SERVICE LETTER

No. 667A

Piper Aircraft Corporation

Stabilator Attachment Bolts

Stabilator Attachment Hardware

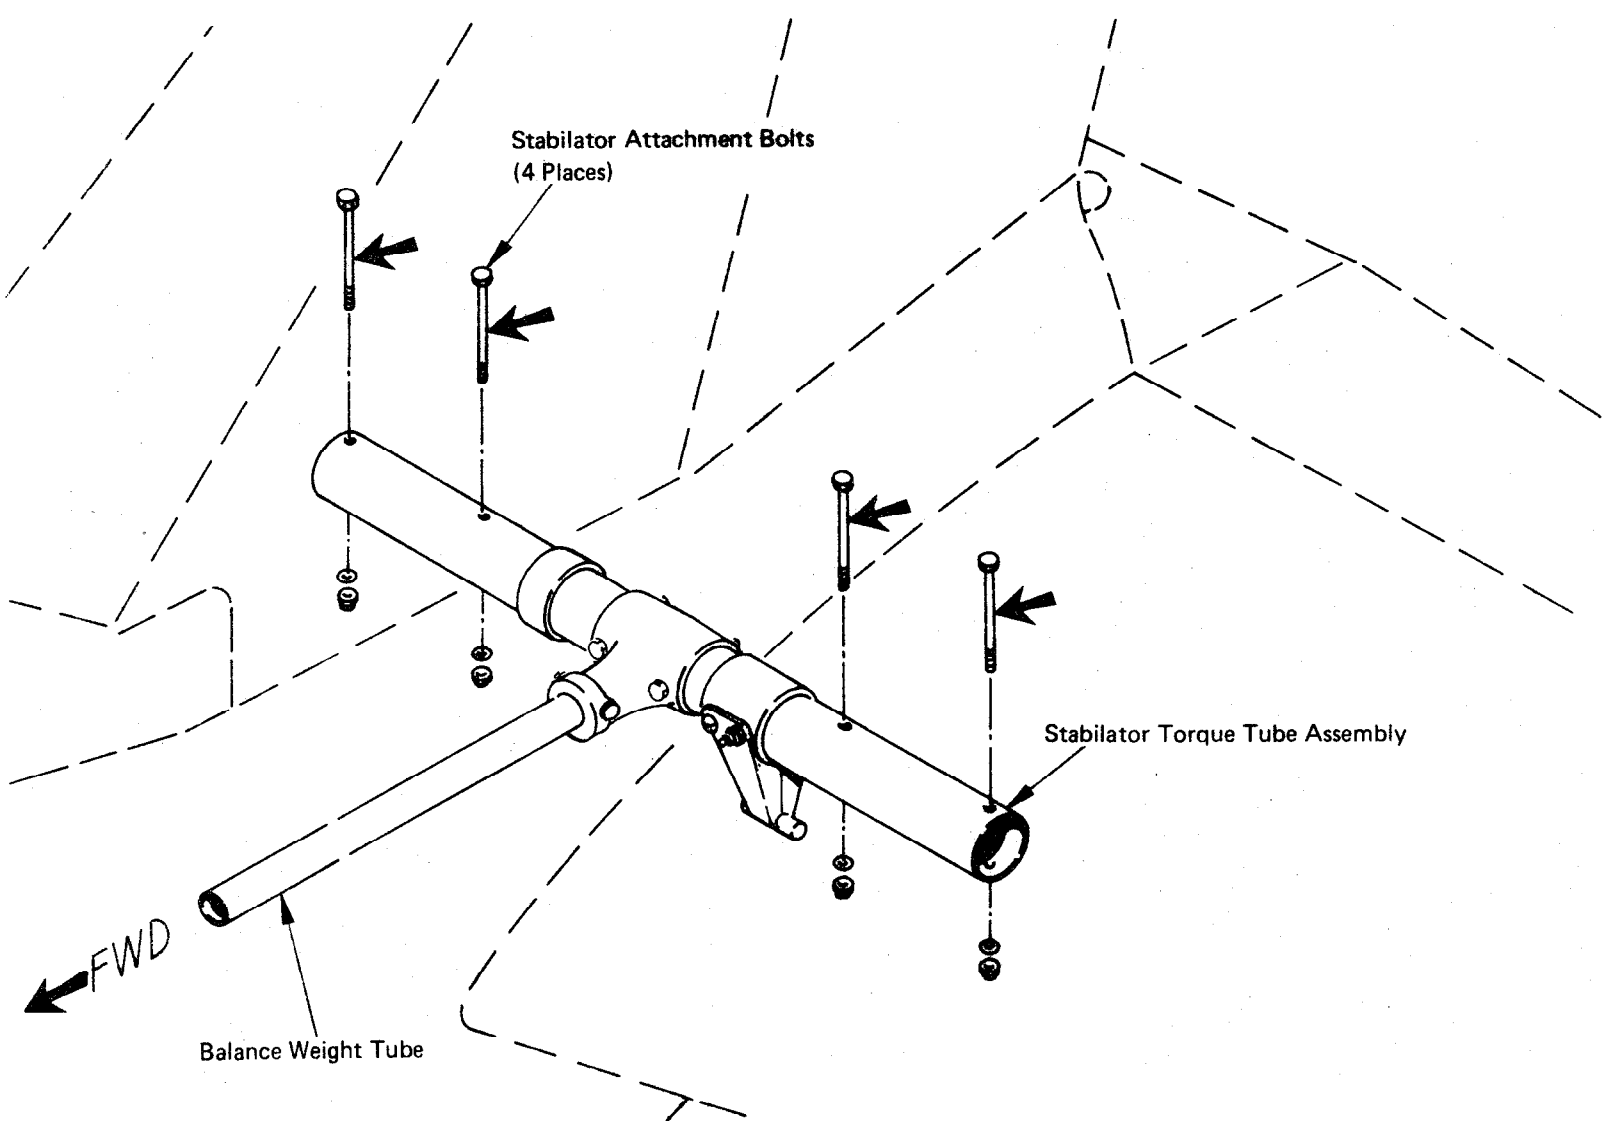
Remove existing stabilator attachment bolts, washers and nuts, indicated on sketch, and install new bolts and attaching hardware. **CAUTION:** Remove and replace one bolt at a time. Refer to sketch for correct replacement hardware identification and proper assembly of bolts, washers and nuts.

2. Correct torque value for bolts is as follows:

- a. PA-24-180/250 and 260 - torque to 30-40 inch lbs.
- b. PA-23-235/250/250 (Six Place) and PA-24-400 - torque to 60-85 inch lbs.
- c. PA-30 - Refer to the Twin Comanche Service Manual (Section 4 - paragraph 49) which states that the nuts ("holding the stabilator to the torque tube") should "be tightened just enough to take the play out of the washers."

Bolt AN174-C32A P/N 502 329 (Corrosion Resistant) or Bolt AN174-32A P/N 402 329 (Non-Corrosion Resistant)
Washer AN960-416L P/N 407 585
Nut MS20365-428C P/N 404 888

Bolt AN175-C32A P/N 502 342 (Corrosion Resistant) or Bolt AN175-32A P/N 402 342 (Non-Corrosion Resistant)
Washer AN960-516 P/N 407 566 (PA-23-235/250 and 250 Six Place only)
Washer AN960-516L P/N 407 586 (PA-24-400 and PA-30 only)
Nut MS20365-524C P/N 404 889
